**DEPARTMENT OF TRANSPORTATION
STATE OF GEORGIA**

FILE: CSNHS-0009-00(323) Coweta Co. **OFFICE:** Engineering Services
P.I. No.: 0009323
I-85 @ CR103 Poplar Road (New Interchange) **DATE:** May 9, 2012

SUBJECT: IMPLEMENTATION OF VALUE ENGINEERING STUDY ALTERNATIVES

VALUE ENGINEERING STUDY RESPONSES
POPLAR ROAD AT I-85 NEW INTERCHANGE
CSNHS-0009-00(323), COWETA COUNTY

Figure 1 Partial Edge Treatment Traverse Section

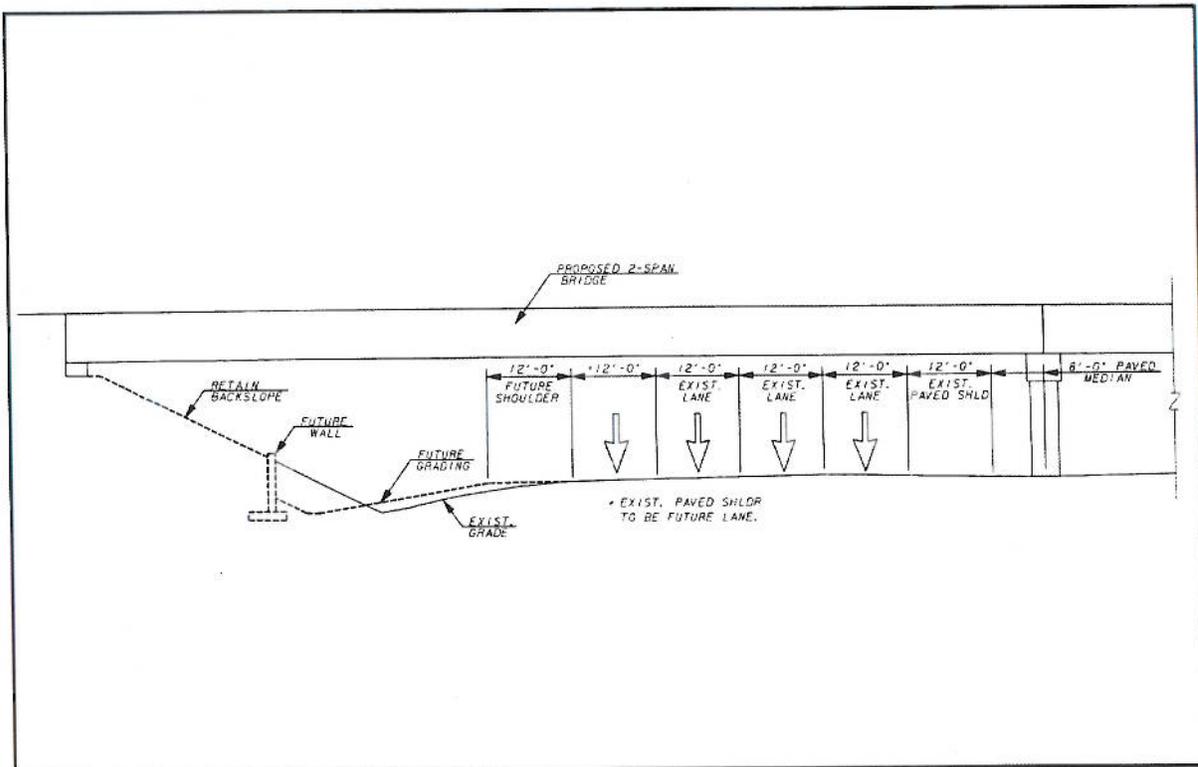
Recommendation B-6: Eliminate additional proposed span length to the Poplar Road Bridge that supports widening for future projects that are not programmed. Original Initial Cost \$208,000; Proposed Initial Cost \$0; Anticipated Cost Savings \$208,000

Response: Yes, will implement. The proposed length of the 2-span bridge with spill through abutments will be determined based upon the width of the existing I-85 cross section with allowances for clear zone, additional roadside edge treatment for appropriate ditch, and concrete slope-pavement on 2:1 slopes. Future construction of an additional outside lane could be accommodated through use of a retaining wall. See Figure 1 "Partial Edge Treatment Transverse Section" below.
